Responses-to-Comments

**Temporary Shop and Services and Eating Place with Ancillary Facilities
for a Period of 5 Years in "Open Space" Zone, Lot 2905 S.C RP (Part) in D.D.104
and Adjoining Government Land, Mai Po, Yuen Long, New Territories**

(Application No. A/YL-MP/382)

Viewpoint 4a

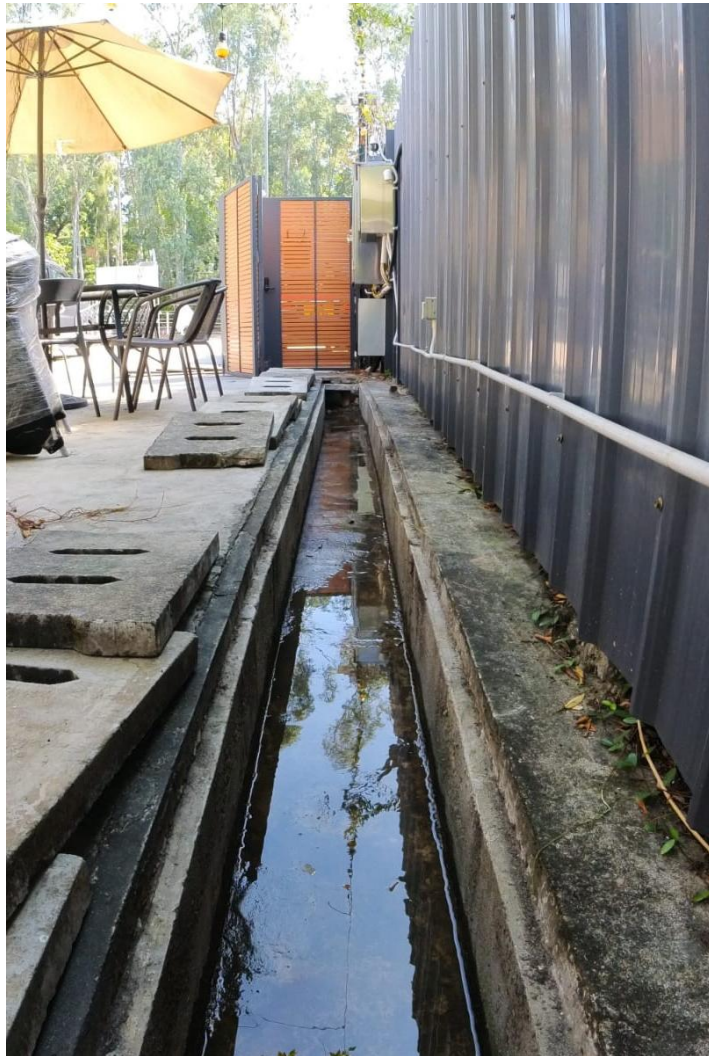
- (i) The applicant has provided supplementary photographic records in response to the following comments from the Chief Engineer/Mainland North, Drainage Services Department:
- Photo 4, 8 and 10 - Waste was observed in the surface channel. Please remove.
 - Photo 7 - The size of u-channel was changed in the middle of channel. Please rectify.
 - Photo 8 - The internal and general view of discharge connection point still cannot be identified. Please provide photo record for general view as well.
